## Springer Hills Plat 2 – Major Preliminary Plat

**Request:** Preliminary Plat Approval of a Major Subdivision Plat

**STAFF REVIEW:**

**SPRINGER HILLS PLAT 2**  
 9277 SE 6TH AVENUE, RUNNELLS, IA 50237  
**PRELIMINARY PLAT**

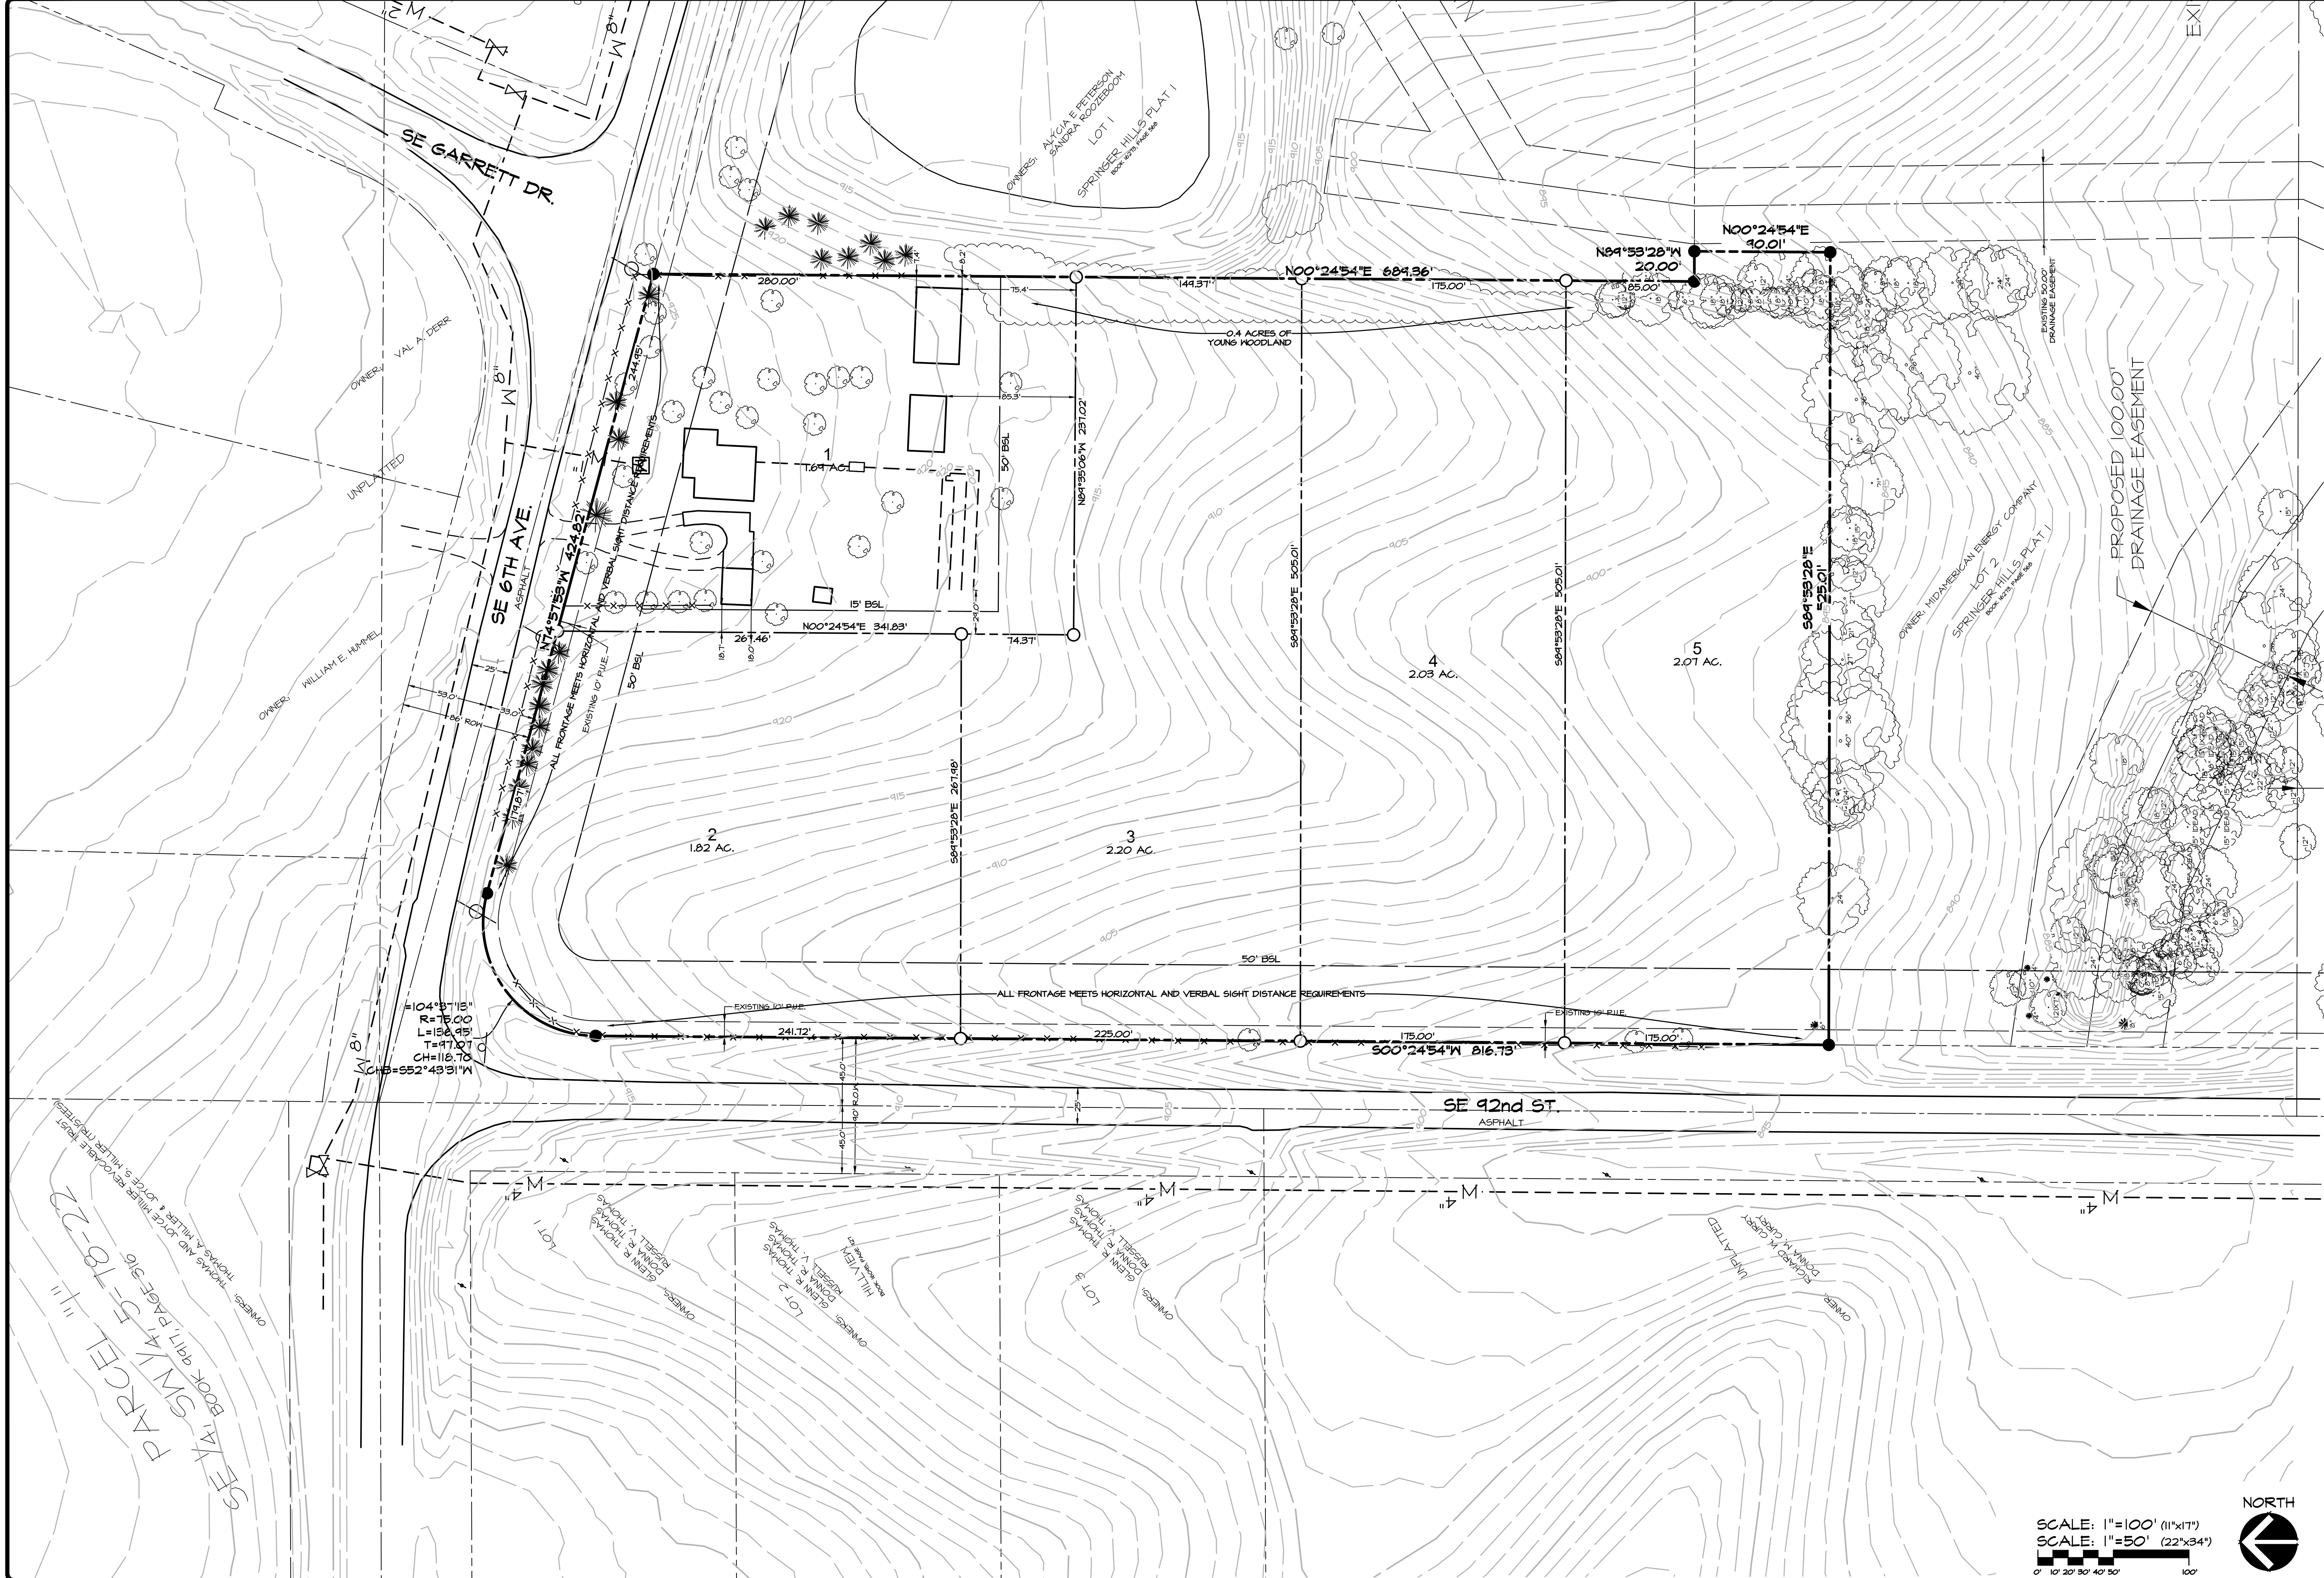
This preliminary plat (*Attachment 'B'*) proposes five (5) single-family residential lots on one (1) parcel totaling approximately 9.81-acres and zoned "RR" Rural Residential District. The subject property has one (1) existing single-family home located at 9277 SE 6<sup>th</sup> Avenue, with a majority of the parcel utilized as an agricultural field. The existing home and accessory structures would be located on proposed Lot 1. Both Lot 1 and Lot 2 will have frontage along SE 6<sup>th</sup> Avenue, with Lot 2 configured as a corner lot with additional frontage to the west along SE 92<sup>nd</sup> Street. Lots 3-5 would have frontage along SE 92<sup>nd</sup> Street. The proposed subdivision is being completed in

accordance with the standard development option meeting the minimum lot width of 140-feet in the “RR” District. The “RR” District requires a minimum lot size of 40,000 square feet with minimum setback requirements of 50-feet for the front and rear setback and a minimum side yard setback of 15-feet. Lot 2 will have two (2) front setbacks due to its configuration as a corner lot. . Each lot has a maximum building coverage of 15%. The proposed lots range in size from 1.69-acres to 2.20-acres.

The subject property is located outside of the floodplain within Zone X, as identified on FEMA FIRM Map #19153C0385F. The topography of the site varies with a high point elevation of 924–feet along the northeastern portion of the property and a low point elevation of 890–feet within the southeastern corner of the property. There are existing woodlands located primarily along the northern and eastern property boundaries as well as scattered throughout the existing homestead site located on proposed Lot 1.

A eight (8) inch water main currently exists along the north side of SE 6<sup>th</sup> Avenue and a four (4) inch water main along the west side of SE 92<sup>nd</sup> Street having Des Moines Water Works (DMWW) as the service provider. DMWW has responded that there will be adequate water available for four (4) additional 1-inch service connections. The proposed lots will be served by on-site wastewater treatment systems. There are existing MidAmerican steel highline utility poles located adjacent to the subject property and running along the western side of SE 92<sup>nd</sup> Street and the southern side of SE 6<sup>th</sup> Avenue.

Staff has reviewed this plat for compliance with the Polk County Zoning and Subdivision Ordinances as a major subdivision plat submittal. The plat is considered a major subdivision due

to the number of lots created in the  $\frac{1}{4}$ ,  $\frac{1}{4}$  Section and the requested waiver. Lot density, dimensions, frontage, access and potential waivers have been reviewed. Pending approval, re-submittals will be needed in order to address staff comments. At this stage, the commission's action would affirm, deny, or amend the overall plat layout. The current layout would require a waiver from the block length requirement.

The staff review took into careful consideration the intersection of SE 92<sup>nd</sup> Street and SE 6<sup>th</sup> Avenue and the potential for future neighborhood connectivity. There are constraints for future development in this area including existing platted lots adjacent to the east, an existing pond and the MidAmerican substation located adjacent to the south. These constraints limit the ability to make significant future street connections, and make street connectivity less viable. It is not anticipated that the adjacent properties to the south and east will be further subdivided to create a need for street connectivity, further supporting the requested proposal without street extensions.

Staff recommends approval of the Preliminary Plat of Springer Hills Plat 2, as well as the requested waiver to the maximum block length standard. The limited options for future street connectivity in this area due to the constraints identified above provided support towards the waiver request.
